## Landscape Referral Response

<b>Application Number:</b>	DA2022/1447
<b>Date:</b>	30/09/2022
<b>Responsible Officer:</b>	Julie Edwards
<b>Land to be developed (Address):</b>	Lot 27 DP 12838 , 108 Plateau Road BILGOLA PLATEAU NSW 2107

The application seeks consent for construction of a swimming pool.

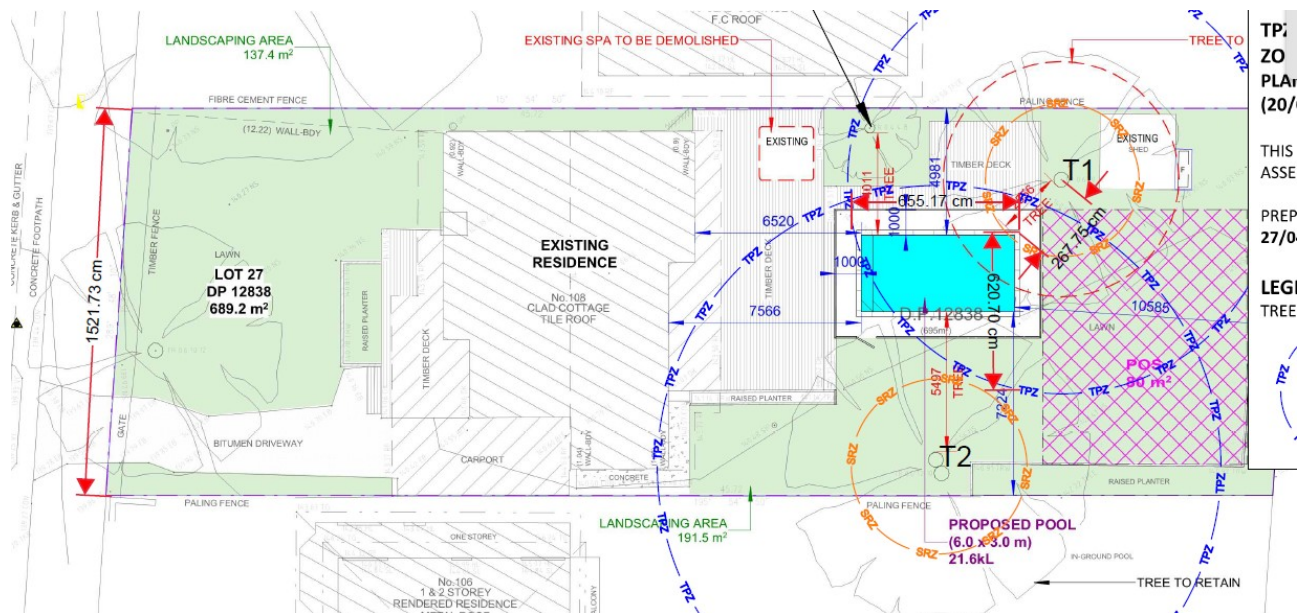
Review of the calculations made under AS4970-2009 Protection of trees on development sites indicates that the impact on the Tree Protection Zone of T1 is 12.66%, rather than the 20% quoted in the Report.

It is apparent that slight relocation of the pool/pool design would enable retention of the trees.

Concern is raised regarding the conclusion in the report:

If concern is held regarding potential roots, root mapping should be undertaken to confirm presence or

otherwise of roots. The recommendation as provided is not considered adequate to enable support for tree removal to be provided.

It is considered that the trees can be retained with amendment to design and that sufficient information to support removal of the trees is has been provided.
